**BEACON FEN**  
**ENERGY PARK**

Planning Inspectorate Reference: EN010151

Applicant's Responses to ExQ2

Document Reference: 9.20

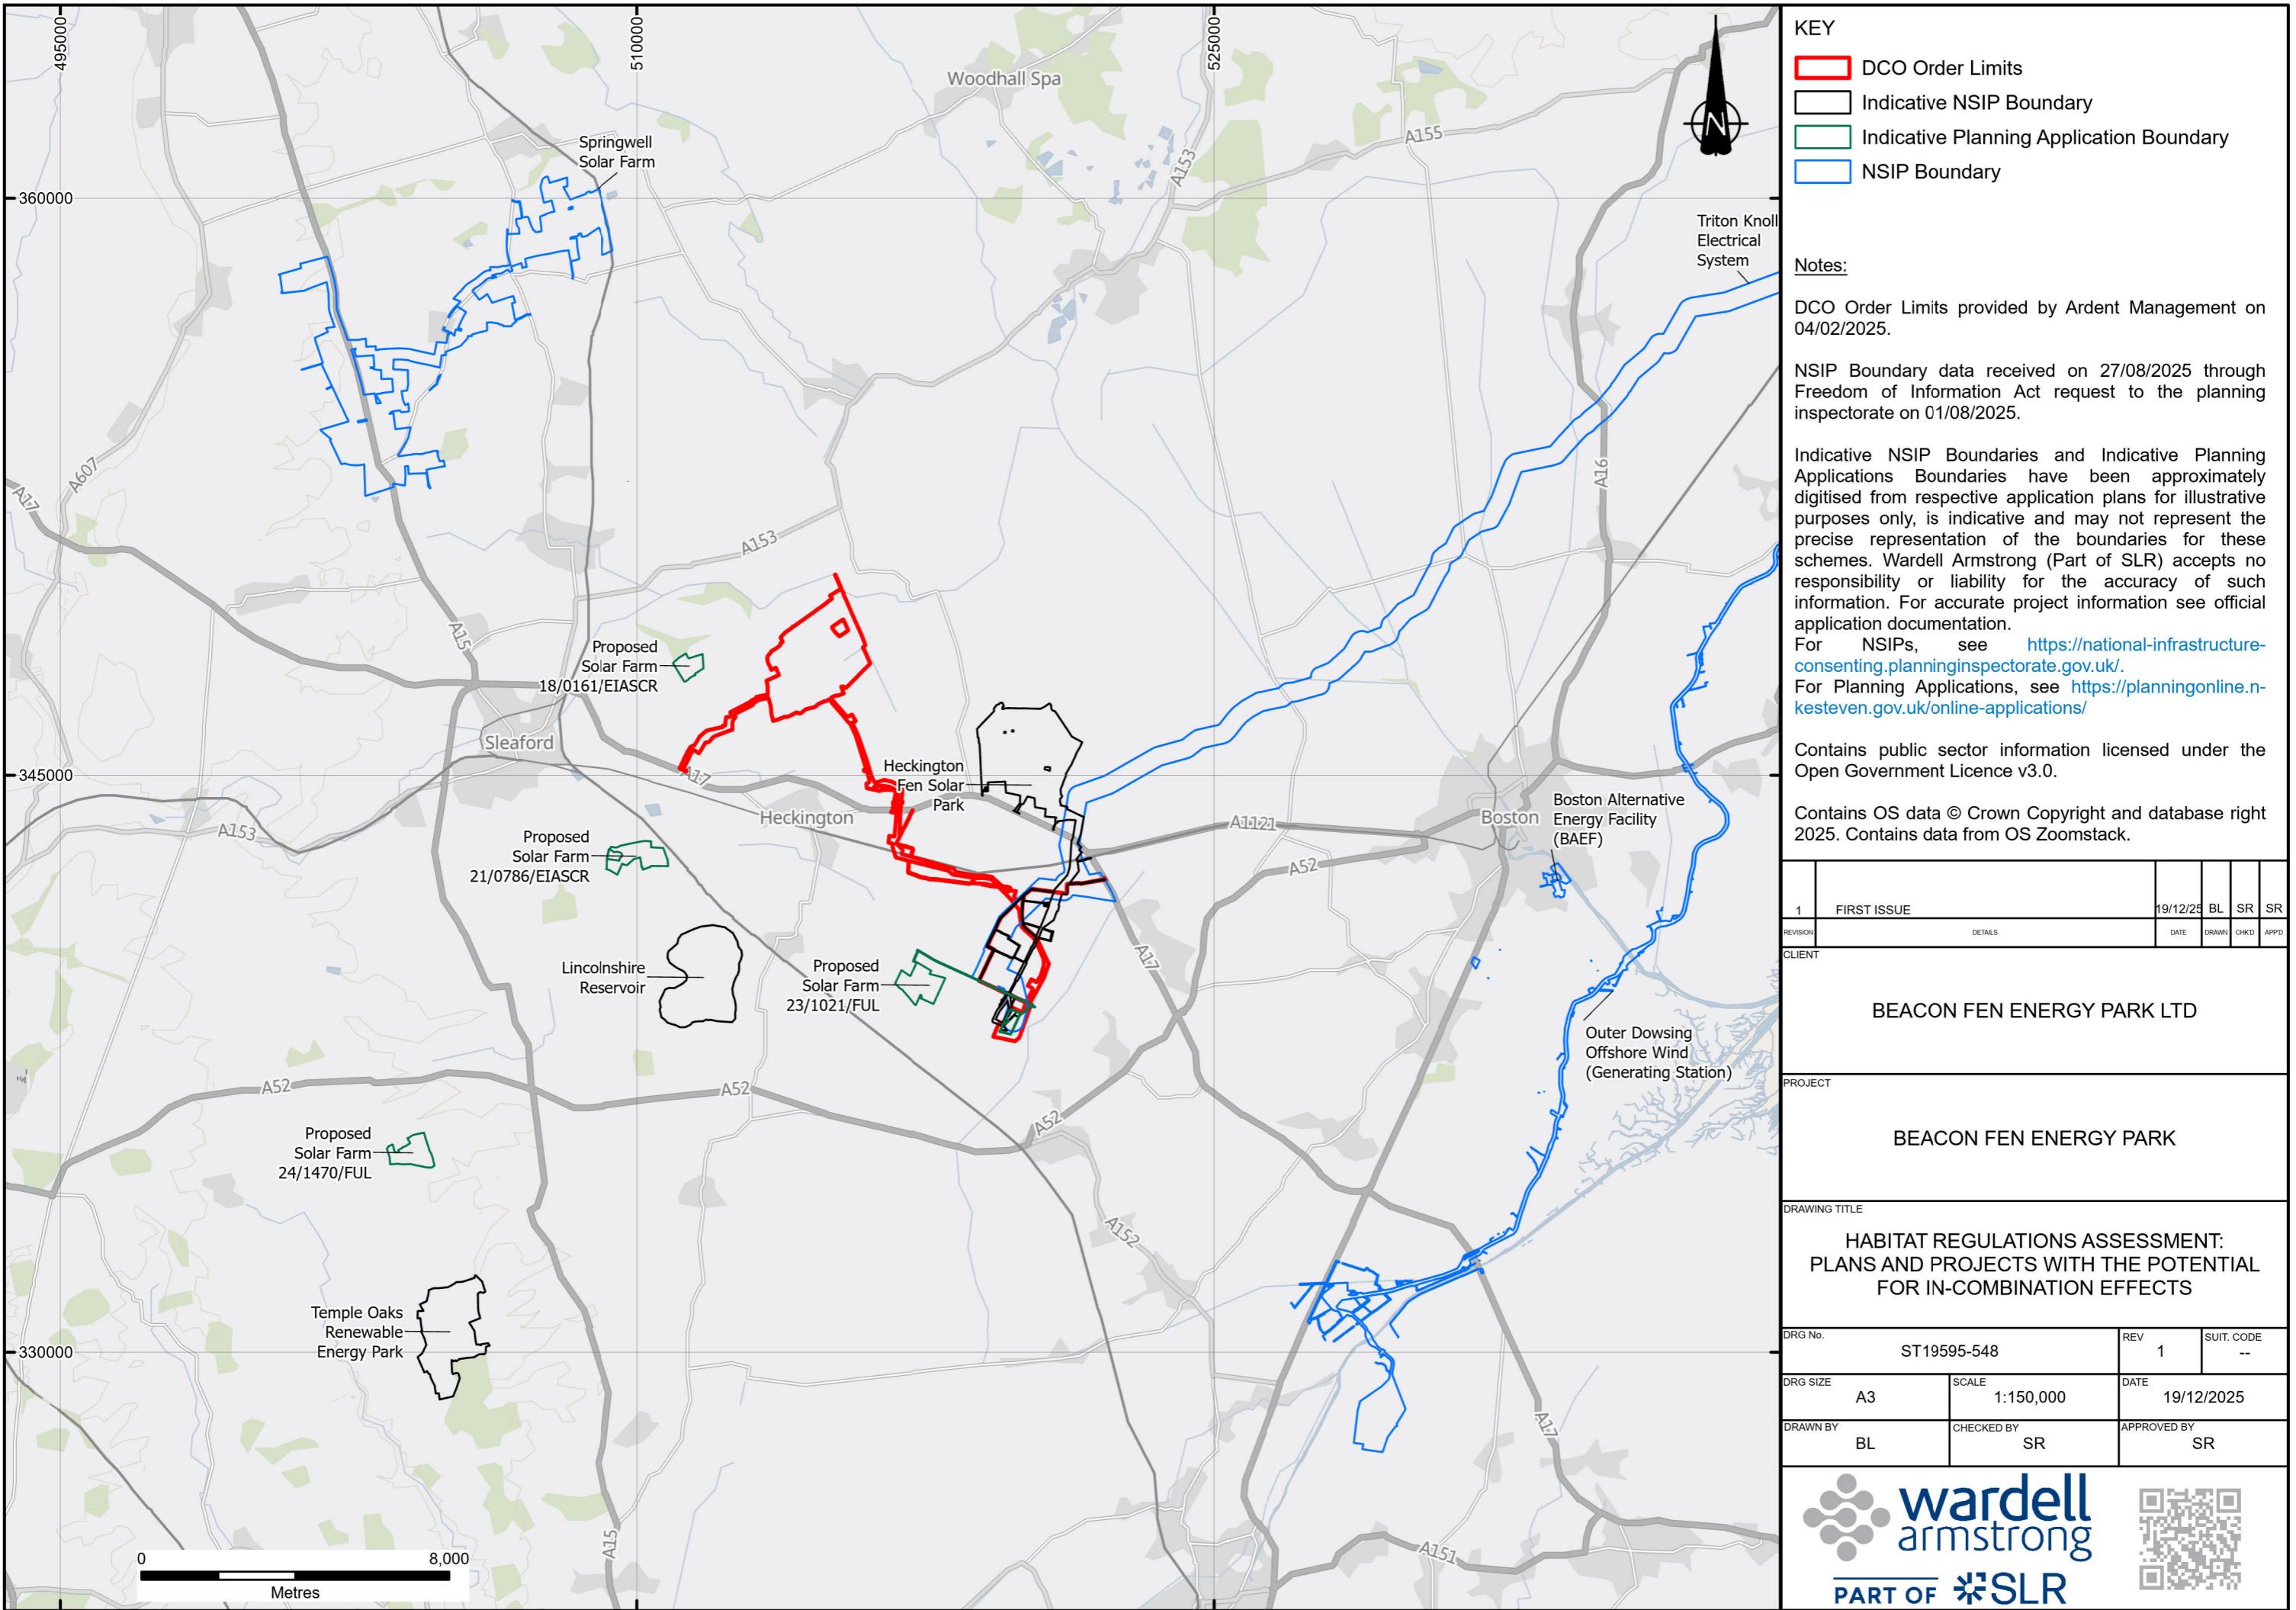
ID	Question to:	Question:	Applicant's Response:
n/a	Applicant	Please provide a figure showing the location the projects included in table 5 of APP-050.	The Applicant has produced a figure, appended below (Habitat Regulations Assessment: Plans and Projects with the Potential for In-Combination Effects, Drawing No. ST19595-548) showing the location of each of these projects.
n/a	Applicant	Can the applicant confirm whether there are any implications to European Sites or the HRA report arising from these projects.	The Applicant has reviewed the additional projects highlighted by Lincolnshire County Council, North Kesteven District Council and Boston Borough Council within <b>Technical Note: Cumulative Effects Assessment Update (Document Ref: 9.21)</b> . One project Land at Little Hale Fen (NKDC ref 23/1021/FUL), approved following an appeal had been considered previously within the HRA ( <b>REP2-013</b> ), and no new ecological information has been provided since this review. All other projects were discounted due to distance from the Site and/or the fact that their construction timings did not overlap with the Proposed Development so impacts could not occur at the same time.

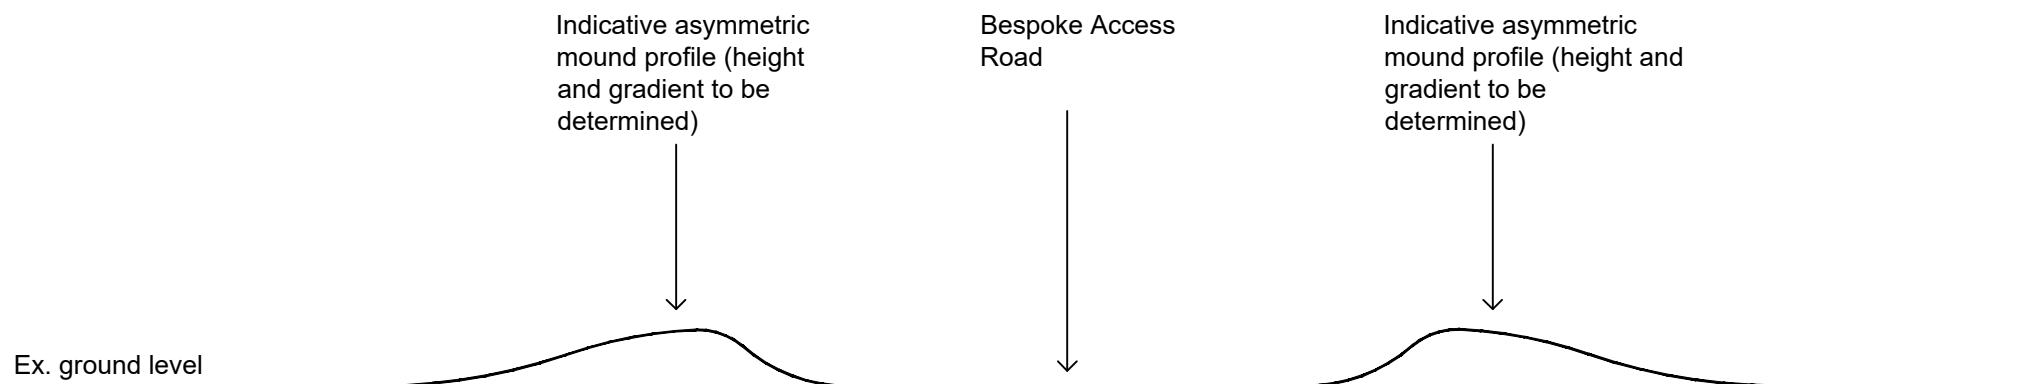
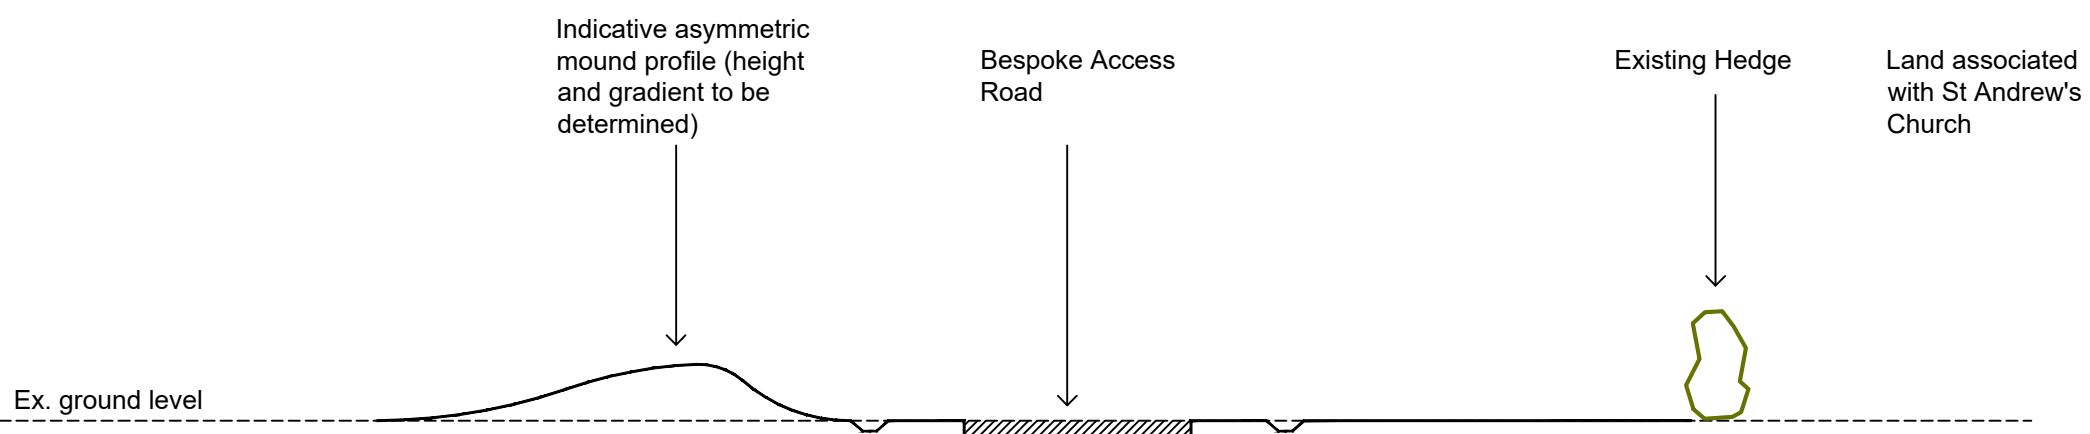
HEN.2.1	Applicant	<p>The applicant has confirmed in [APP-059] that the Church of St. Andrew at Asgarby would be impacted by the Bespoke Access Road, particularly during construction stage, due to new movement in the landscape, an increase in traffic noise, increase in vehicular lighting and increase in air pollutants and the presence of new highways infrastructure. Although it is accepted that at operation stage, all the factors that the applicant has considered which are linked to the use of the Bespoke Access Road will be greatly reduced, can the applicant please explain how the presence of a new highway infrastructure was considered and why its effect is not deemed to be significant?</p> <p>The Bespoke Access Road will during the construction phase result in a temporary moderate adverse short-term effect that is considered significant. The Applicant has developed further detail of the soil stockpiles (as outlined within Chapter 2 Proposed Development (APP-053) resulting from construction of the Bespoke Access Road ('BAR') to illustrate how these can be utilised as bunds, or sloping mounds, to mitigate the impact of the BAR. The indicative details of these bunds have been developed through workshops, and the following matters have been considered:</p> <ul style="list-style-type: none"><li>• Indicative soil volumes have been calculated to identify the likely scale of the stockpiles;</li><li>• The height of the stockpiles has been informed by these volumes, whilst ensuring they are not so high as to have their own impact on the landscape;</li><li>• The incline of the stockpiles will be appropriate ensure stability, whilst incorporating design measures (as set out below) and</li><li>• The stockpile locations have been designed around flood constraints.</li></ul> <p>The Applicant has updated the <b>Landscape Strategy Plan (Document Ref: 6.4.42)</b> to illustrate the indicative location of these soil stockpiles. The indicative design approach, as set out above, is illustrated in <b>Appendix 2 - Soil Stockpiles Indicative Cross Section</b>. It is intended to screen views of the BAR whilst limiting the extent to which the stockpiles are perceived as engineered features in a characteristically gently undulating landscape. The stockpiles will be seeded with an appropriate seed mix which will facilitate an appropriate visual association with the agricultural landscape.</p> <p>At this stage it is anticipated that the stockpiles will vary in height between approximately 0.5m and 1.0m and will be located in areas where adverse effects in relation to views of St. Andrews Church have been identified, as well as adverse visual effects on PRoW. The stockpiles have been placed in a manner to screen the BAR in views from the west and south, when looking across the BAR towards Asgarby Church and Hall.</p> <p>The approach to the design of the stockpiles is to create a 'false cutting' using an asymmetric soil profile with a relatively gentle slope to the external aspects of the road corridor and a steeper slope adjacent to the road. This is a method used within designed parkland landscapes; the slope on the viewer's side takes the view across the mound and then the road, giving the impression of a continuous uninterrupted view across the landscape (often referred to as a ha ha). This will reduce the visibility of the BAR in views from the west and the south, in particular views from PRoW KkLT/4/2 and the A17.</p> <p>During the decommissioning phase the soil stockpiles will be reinstated, following appropriate environmental standards and guidance as set out within the <b>Outline Soil Management Plan (Document Ref: 6.3.95)</b> and secured by <b>Requirement 16 of the Draft DCO (Document Ref: 3.1)</b>.</p>

<p><b>Appendix 1 of the Design and Access Approach Document (DAD) (AS-019)</b> outlines the ES Design Parameters and Additional Design Principles for the BAR (Work No.8), which contribute to keeping the impact of the BAR to a minimum during its operation. These parameters and principles will be adhered to and secured within requirement 5 of the <b>Draft DCO (Document Ref: 3.1)</b>. The Outline Design Principles within the DAD confirm that the BAR will in general have the appearance of a farm track or rural driveway, though wider, with type 1 granular surfacing. Street lighting, road markings and other street furniture are not proposed except at times or in locations strictly required for safety purposes.</p> <p>Measures outlined within Appendix 2.3 Embedded Mitigation (APP-076) have been put in place in order to mitigate environmental impacts of the BAR, such as reinstatement of vegetation and hedgerows lost during the construction of the BAR, which is secured within the <b>Outline Landscape and Ecological Management Plan ('OLEMP') (Document Ref: 6.3.19)</b>.</p>
